PLAN COMMISSION STAFF REPORT

Tuesday, October 13, 2020 – 6:00 p.m.

Site and Landscaping Plans

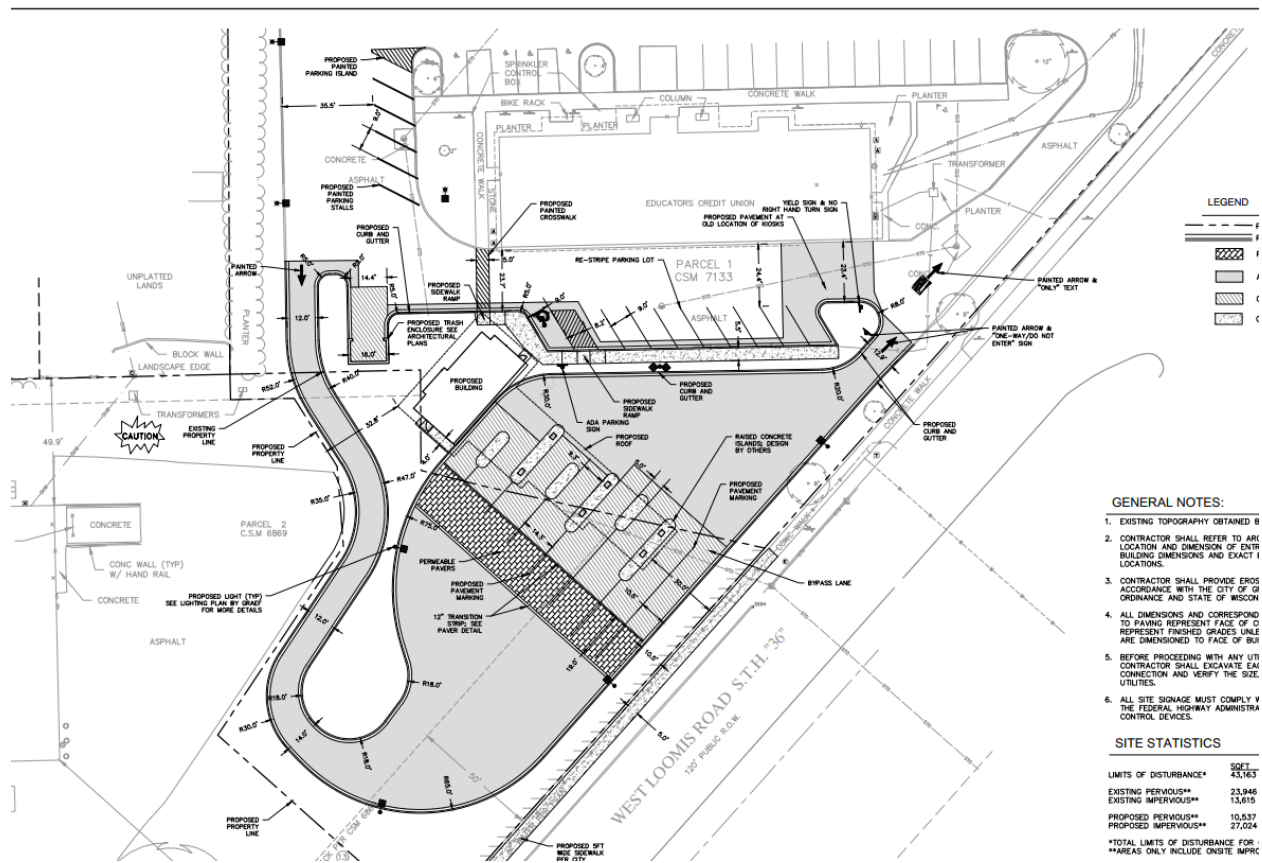
The proposed site plan includes a new driveway to the south of the existing ECU branch building to accommodate the new drive-thru teller building and the 6-lane drive-thru with a 7th lane for the ATM. The drive-thru lanes will be covered by a canopy. The new lanes will then synch up with the existing exit lane, exiting out to W. Cold Spring Rd. There are no new road curb cuts proposed. In addition, several areas of existing parking will be reconfigured as parking of the site modification. All 39 parking spaces on the north end of the building will remain as is. There are currently 11 spaces on the west end of the building, which will be reduced to five (5) spaces. And there are current 16 spaces on the south side of the property, which will be reduced to 10 spaces. That's a total loss of 12 off-street parking spaces. Staff requests a detailed parking inventory on revised site plans.

The existing drive-thru canopy will be demolished and the parking lot will be reduced in size and reconfigured to the south of the building to accommodate the demolition and construction of the new teller building and drive-thru lanes.

The refuse enclosure at 4000 will be relocated east to accommodate the new driveway. A detailed refuse enclosure plan needs to be submitted for review. The enclosure should be constructed of board-on-board material or a masonry material with a personnel door or maze wall.

1. Revised Site, Landscaping and Architectural Plans being submitted to the Community Development Division to show the following: (a) window material details on the new building; (b) a concrete window sill being located under new windows on the new building; (c) four-sided refuse enclosure details on both site plans showing the enclosures being constructed of board-on-board or masonry material and including a personnel door or maze wall; (d) parking inventory on both site plans; (e) depth of parking spaces being noted; (f) an ADA-accessible ramp on the southwest side of the existing building; (g) a one-way arrow being painted on the parking lot on the south side of the existing building at the drive-thru exit; (h) additional landscaping at the southwest corner of the drive-thru lane; (i) pole base details being provided showing that pole bases do not exceed six (6) inches in height within landscaped areas; and, (j) wood mulch being installed in all landscape beds—no stone mulch permitted.

Architectural Plans

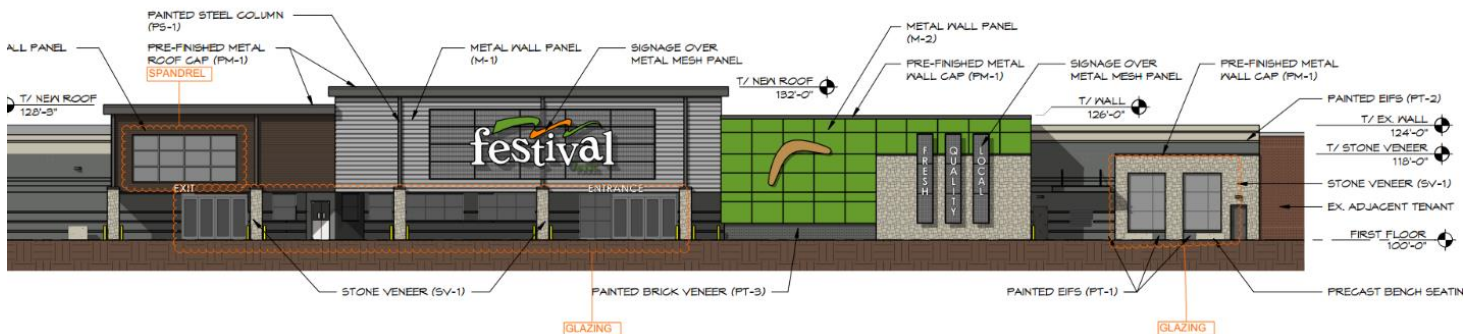
Festival is proposing a new east/front façade to the existing building and removal of the former auto section that extends out at the southeast corner of the building. The front façade includes a variety of building materials, fitting their new prototype design, similar to the existing grocery store in Hales Corners. New materials include: a silver rib profile aluminum wall panel at the main entrance; a gray painted brick veneer base to the north of the front entrance; two (2) green aluminum wall panels; a wood-grain pattern aluminum wall panel surrounding the building exit; a silver aluminum wall panel at the tenant entrance; three (3) metal canopies at the tenant entrance, the wine/spirits/beer entrance, and a small one located as decoration to the north of the main entrance, and new building lights. The façade also includes sections of stone veneer. Staff is requesting

Staff recommends additional stone veneer

two (2) additional sections of stone veneer on the south end near the tenant space. What remains of the existing EIFS facade will be painted a gray tone, go along with Festival's corporate color scheme. Also incorporated into front façade is a section of spandrel windows above the grocery store's exit doors. Clear glazed storefront windows will be constructed on the north end of the front façade and along the building's entrance and exit. All building entrance doors will be constructed of clear glazed glass. Festival is using some architectural signage features to break up the façade as well. A master signage plan package will come before the Plan Commission at a future date. The proposal also includes eight (8) concrete planters for decorative plantings, six (6) concrete benches/tables, a picnic table, and a bike rack along the front facade.

1. Revised Site, Landscaping and Architectural Plans being submitted to the Community Development Division to show the following: (a) additional stone veneer in two sections along the east building elevation; (b) new board-on-board or PVC-type material fencing and cut sheet along the south property line; (c) board-on-board or masonry material refuse enclosure with a personnel door or maze wall; (d) landscaping being wrapped around the southeast corner of the building for a length of 50 feet along the south building elevation; (e) modified maneuvering of pedestrian/sidewalk at the section just north of Great Midwest Bank; (f) a landscape island being added to the eastern portion of the parking lot to force traffic to take the S-shaped driving pattern; (g) pole base height being labeled; and, (h) landscaping species modifications at the request of the City Forester.

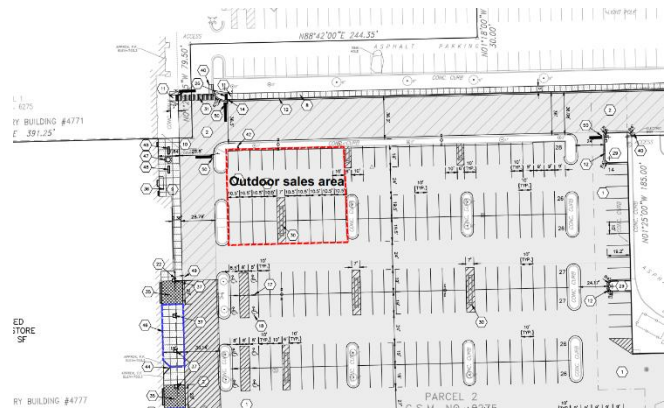
Staff has been working with the Festival architectural and engineering team on some additional site improvements. The traffic flow on the eastern side of the parking lot, abutting the outlots, doesn't provide a smooth north/south traffic pattern. However, if the site were reconfigured to do so, it would require the relocation of several light poles, landscape islands, and reconfiguring driveway entrances to abutting outlots and parcels. North/south traffic is supposed to make an S-shaped turn if property following the drive aisles. However, most traffic going from north to south doesn't make the turn and continues south, driving through parking stalls. Festival has suggested constructing a large landscape island, forcing traffic to follow the proper drive aisle, making it a safer north/south route. A revised site plan will be forthcoming.

Staff also recommended landscaping on the southwest corner of the site, where there are no landscape islands. Festival has suggested wrapping landscaping around the southeast corner of the building and running the landscaping approximately 50 feet west, along the south building elevation.

The south property line is bordered by an old chain link fence that is in disrepair. Staff has communicated to Festival the request to replace this fence with either a board-on-board or PVC-type material fence.
